Wastewater Management System Design Brief

***Sandy Bar Road Manitoba Metis Federation
Seniors Housing Complex***

July 27, 2020

From: [Parsons, Travis](#)
To: [Sagan, Barsha](#)
Cc: [Malkowich, Brian](#)
Subject: RE: Update on NOA for MB-housing-st-laurent-lagoon_file318.10
Date: May 23, 2024 4:29:35 PM

LOT SERVICES PLAN
MANITOBA METIS FEDERATION
ST. VETERANS MEMORIAL ROAD
ST. LAURENT

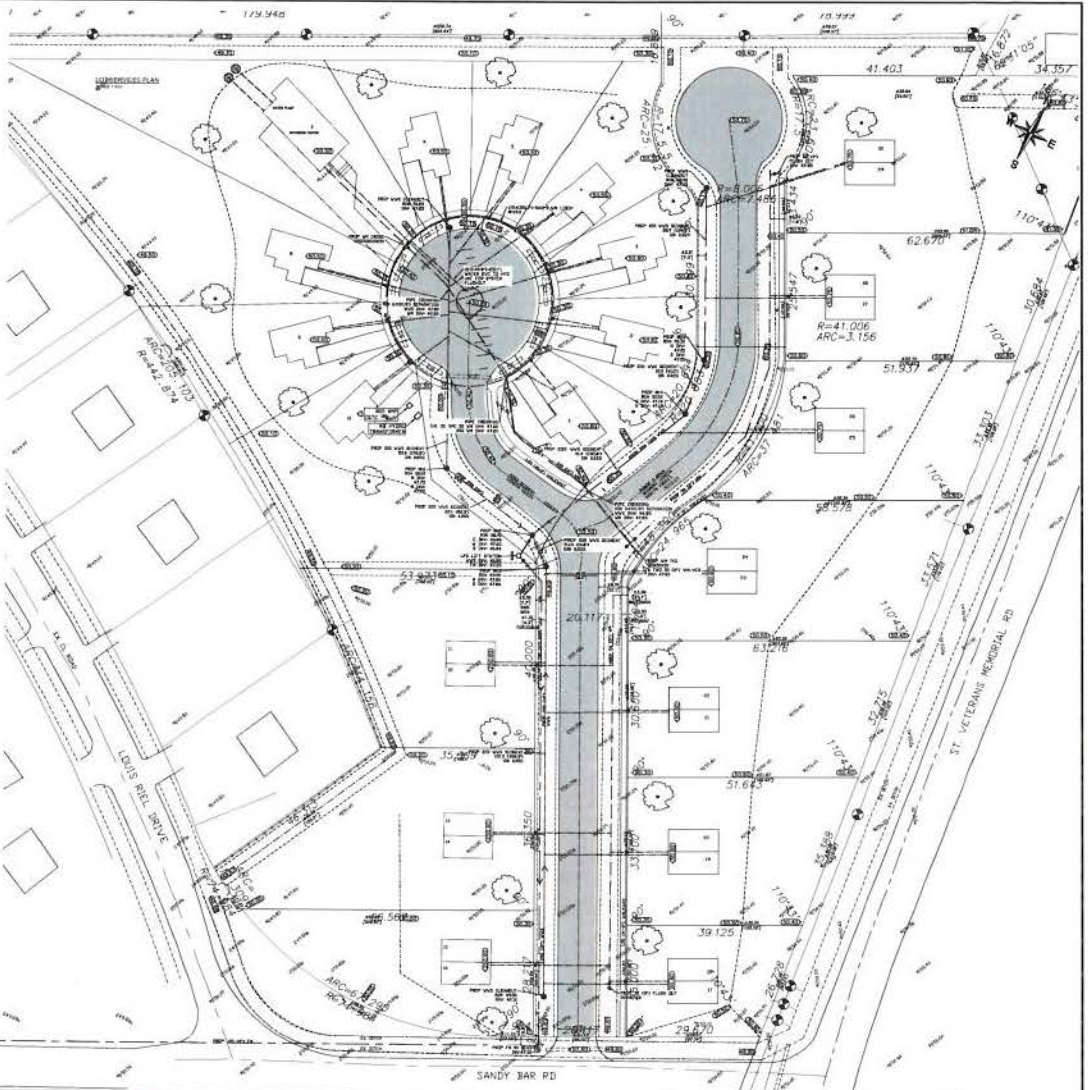
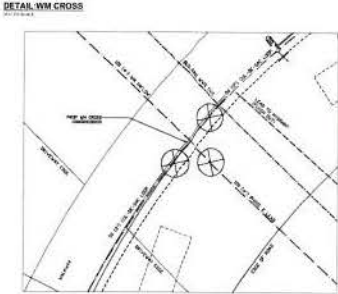
6. The engineering drawings submitted with the Notice of Alteration documents are not readable. Please resubmit engineering drawings such that the dimensions are readable. It is recommended that any proposed splash pad in the primary cell should have a dimension of 3m by 3m.

8. Please provide a signed copy of the Services Sharing Agreement between Manitoba Metis Federation and Manitoba Housing.
9. Please update engineering drawings with the location of the septic tank. Please also include a cross section profile showing the relative elevation of top and bottom of the tank, and the elevation of the grade.

10. Please note that the proposed septic tank will be required to include a high level alarm. Please update your drawings accordingly.
11. Please also note that a certified operator will be required to monitor the septic tank and the lagoon.
